STERLING RANCH EAST FILING NO. 4

CONSTRUCTION DRAWINGS

JUNE 2026

STERLING RANCH EAST FILING NO. 4
CONSTRUCTION PLANS
GRADING AND EROSION CONTROL PLAN
INITIAL PHASE

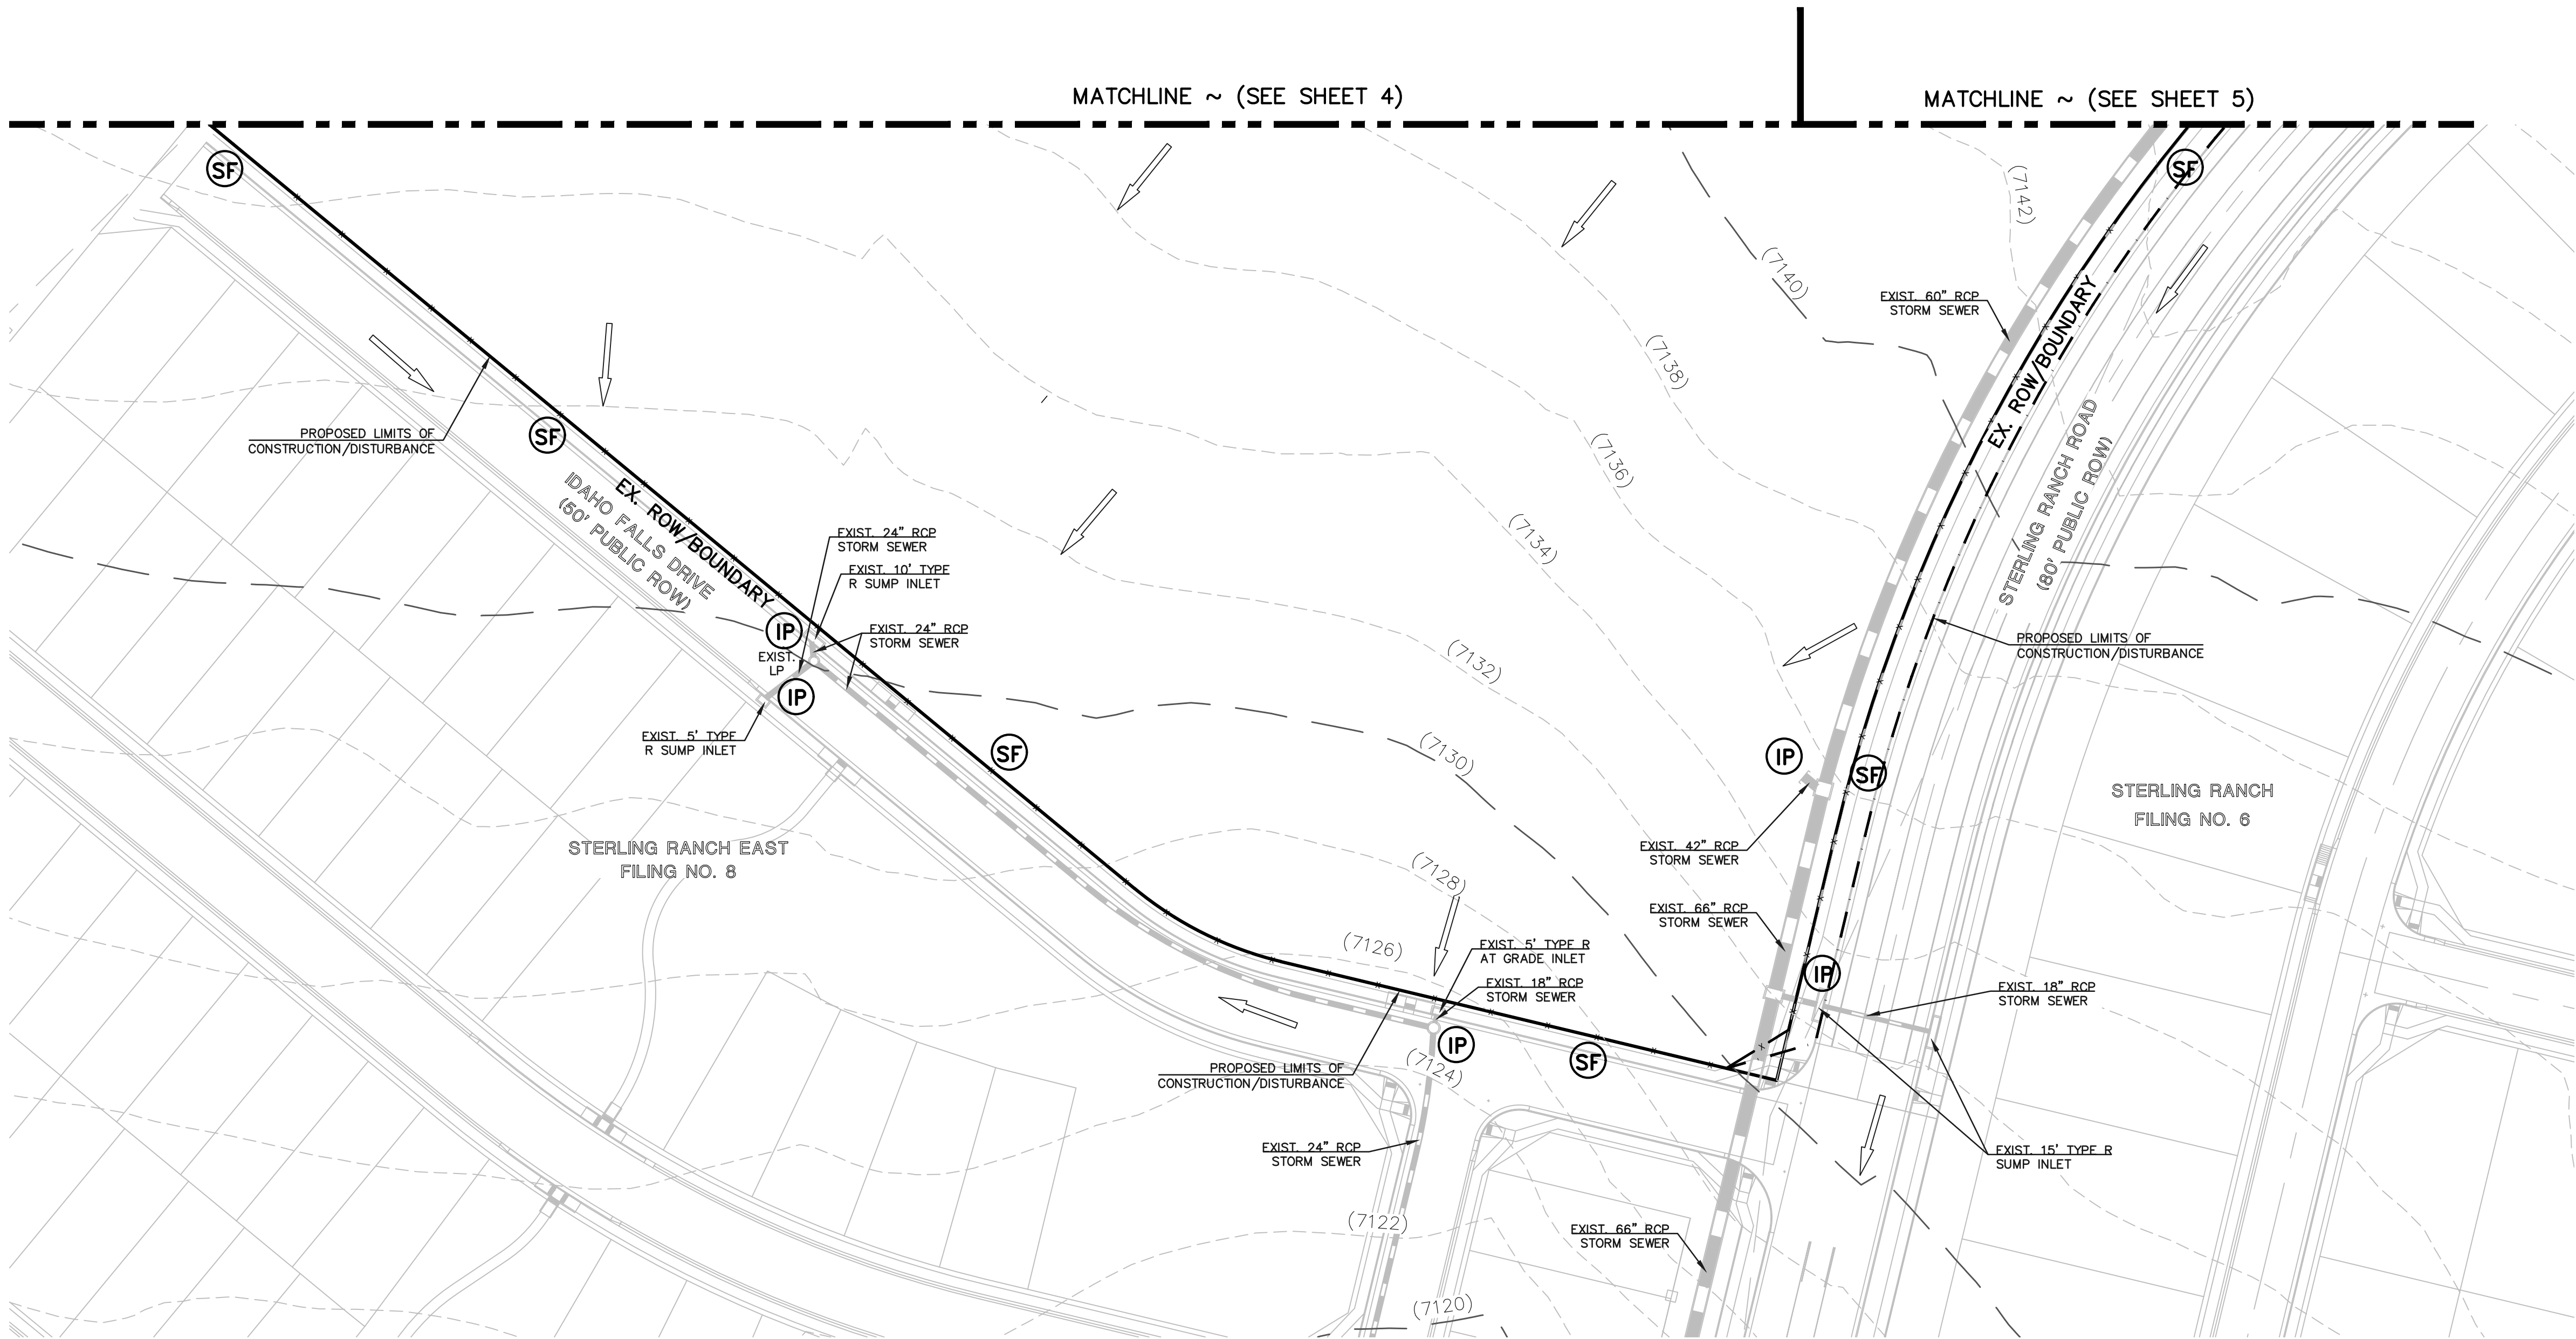
Previous sheet shows S/M within LOD of tract A. Continue S/M into the portion of tract A on this sheet. Include this S/M area in FAE if not already accounted for.

STERLING RANCH EAST FILING NO. 4 CONSTRUCTION PLANS GRADING AND EROSION CONTROL PLAN FINAL PHASE			
DESIGNED BY	PRA	SCALE	DATE 6/1/2026
DRAWN BY	ESO	(H) 1"= 50'	SHEET 11 OF 37
CHECKED BY		(V) 1"= N/A	JOB NO. 1183.41

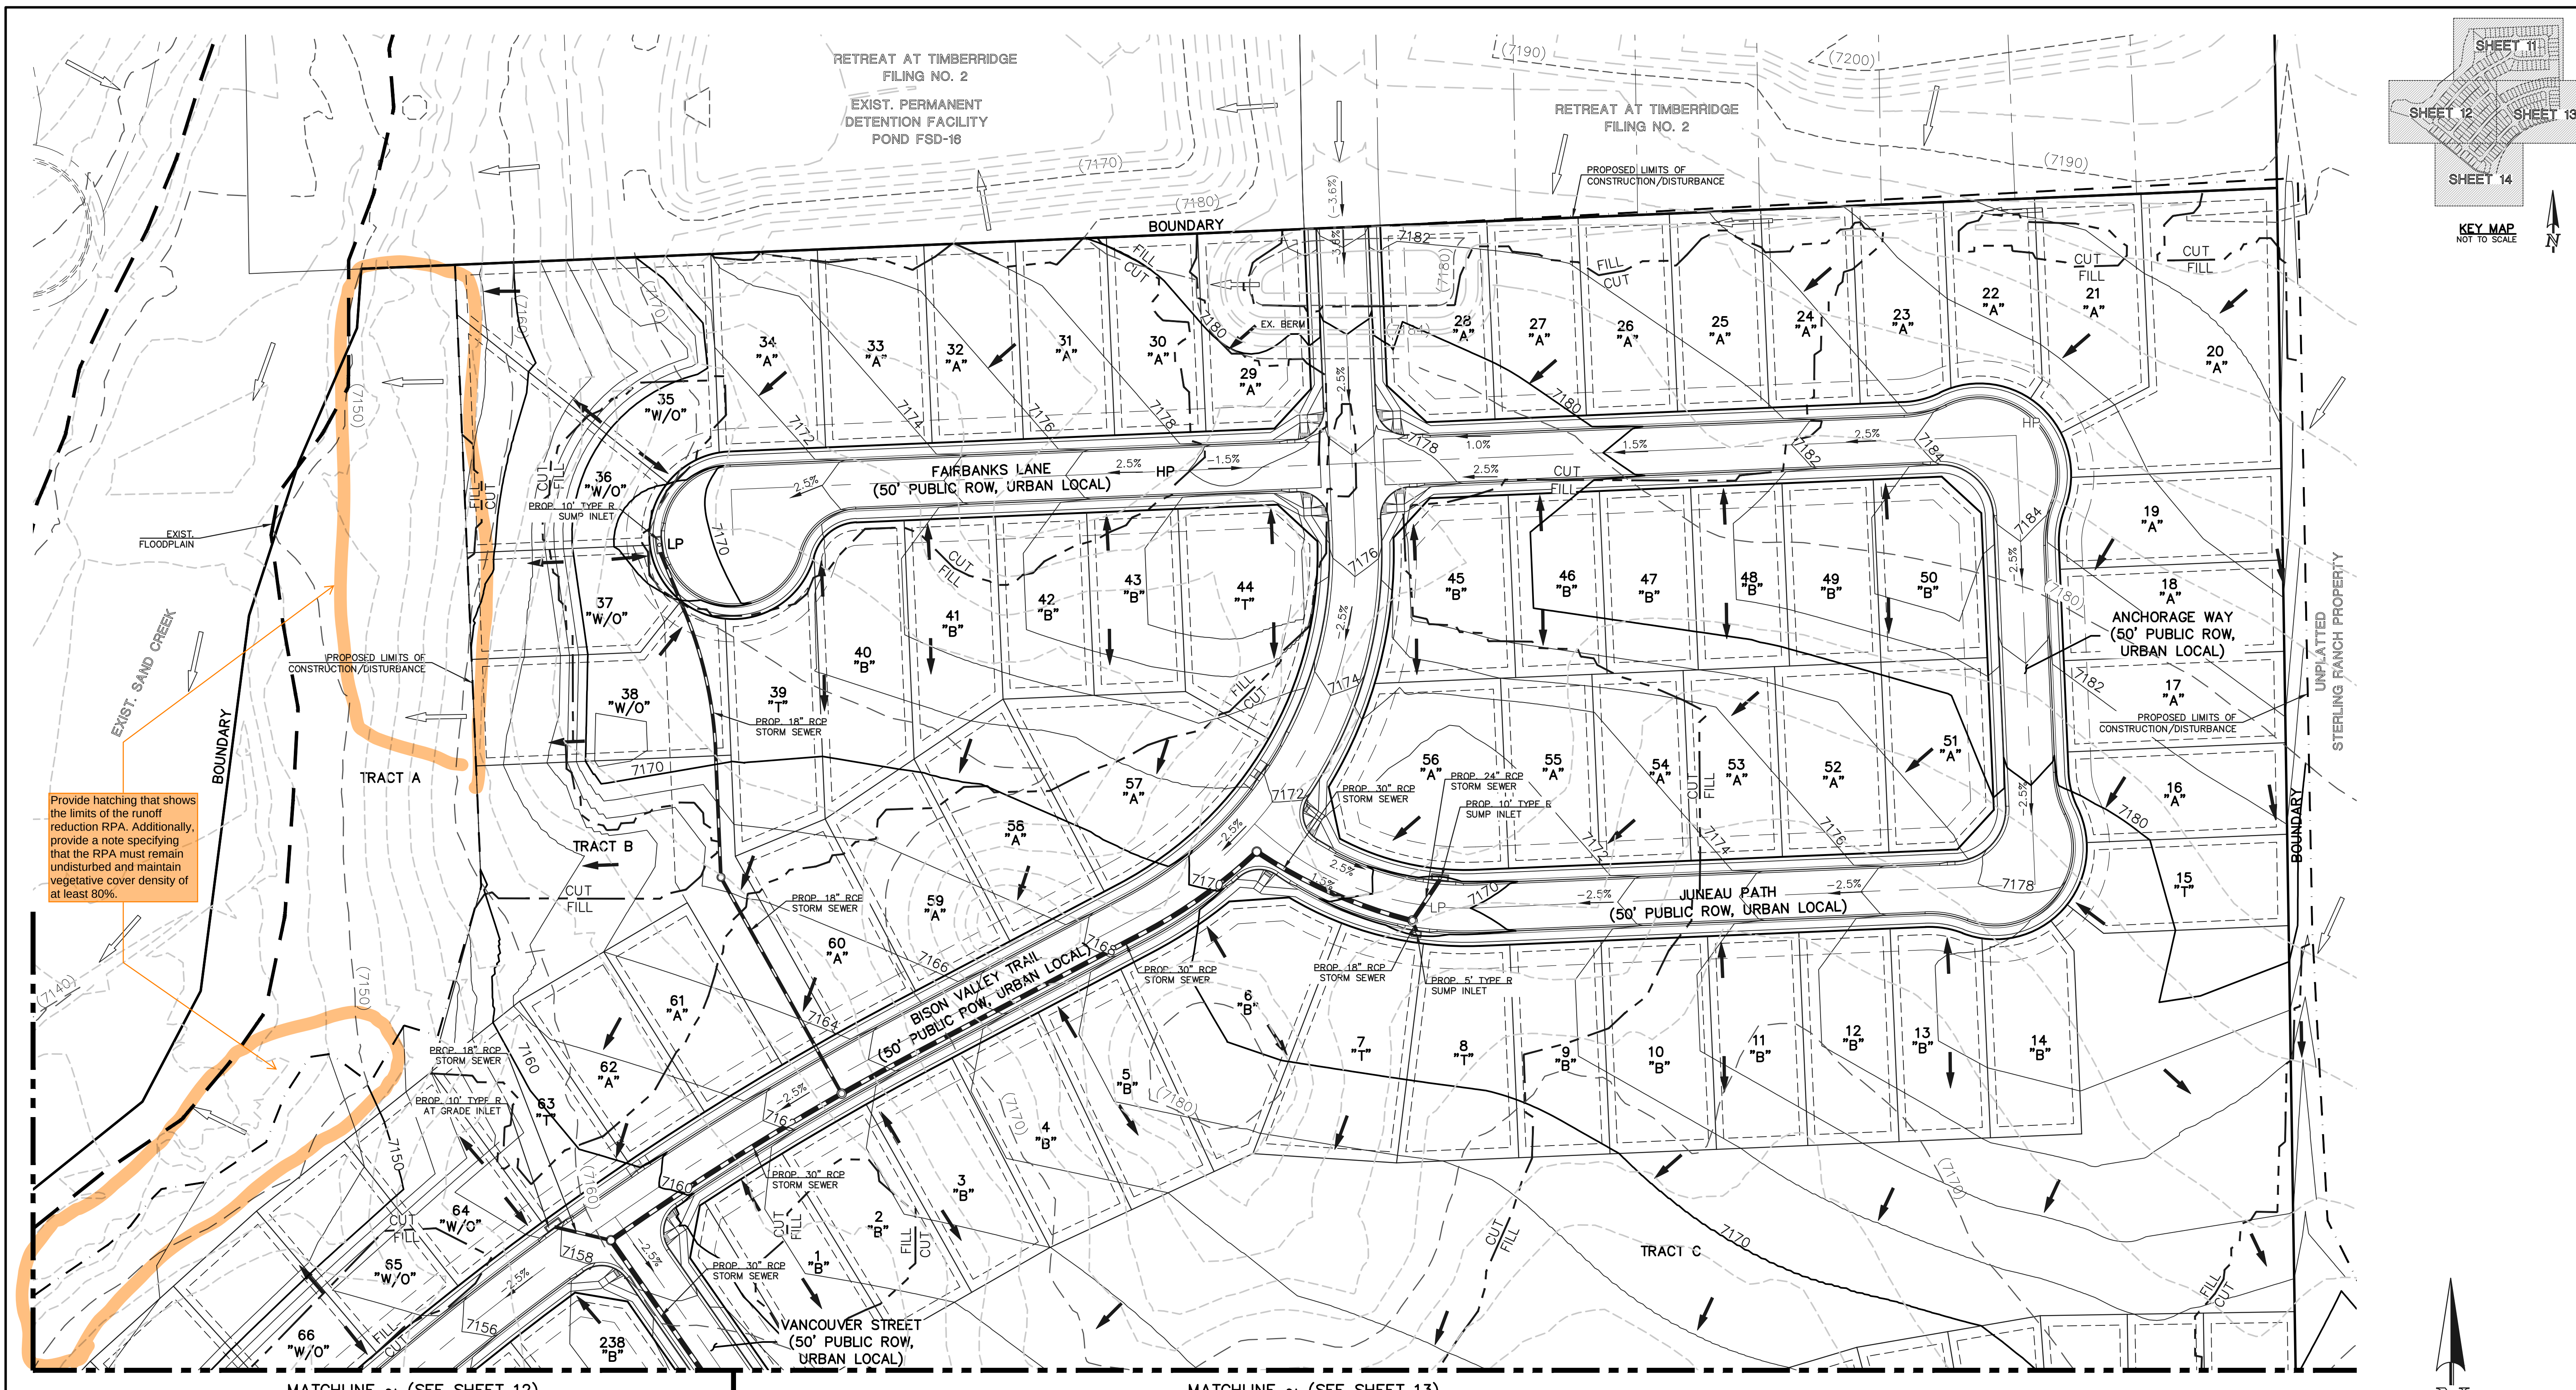
Provide hatching that shows the limits of the runoff reduction RPA. Additionally, provide a note specifying that the RPA must remain undisturbed and maintain vegetative cover density of at least 80%.

STORM SEWER RUN 2 -
LATERAL 2 (PUBLIC)

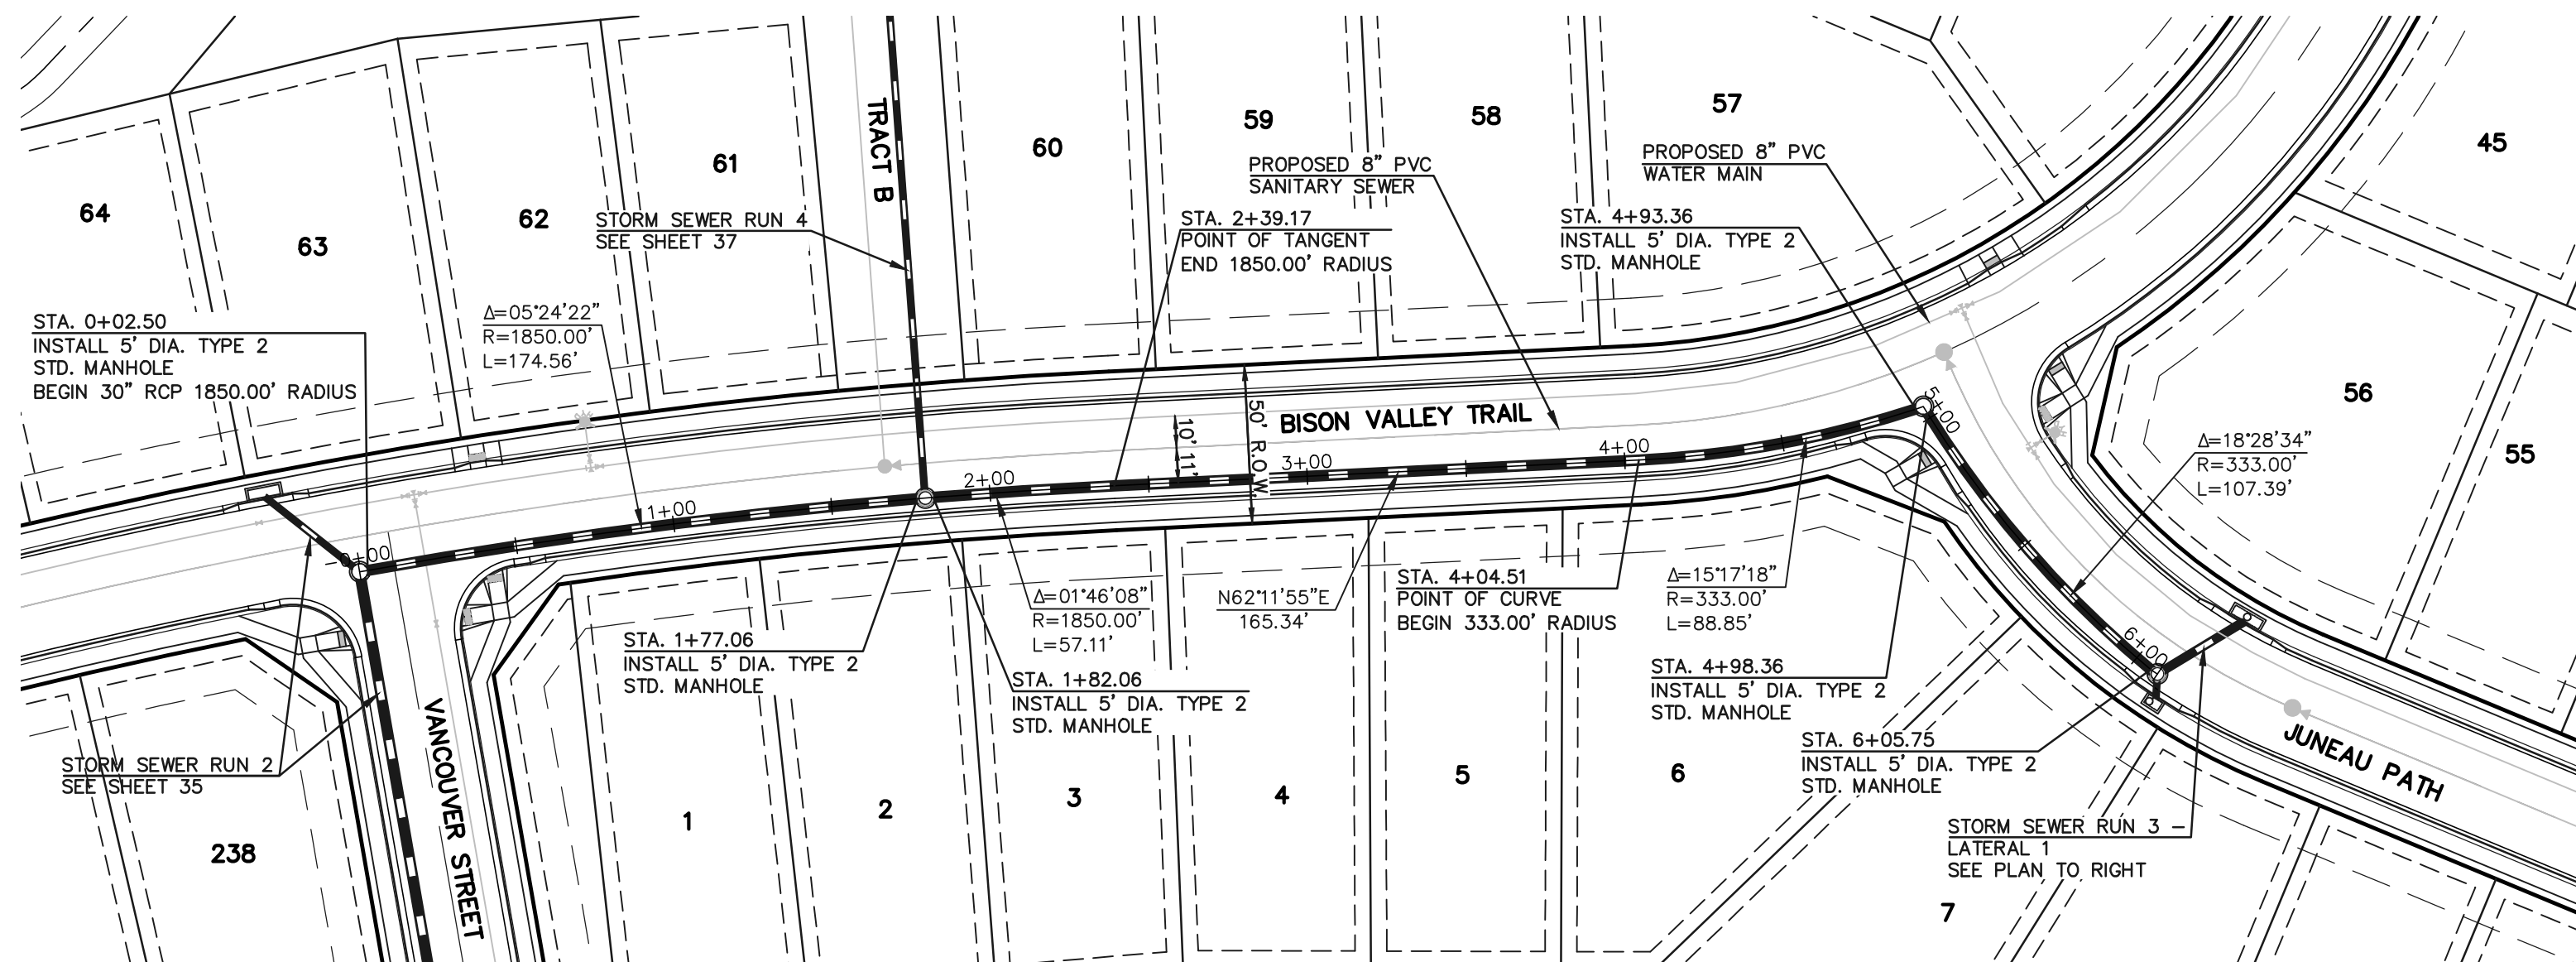
Labelled as 10' Type R Sump Inlet in
Storm Sewer Run 2 - Lateral 2 (Public)
profile below. Please revise.
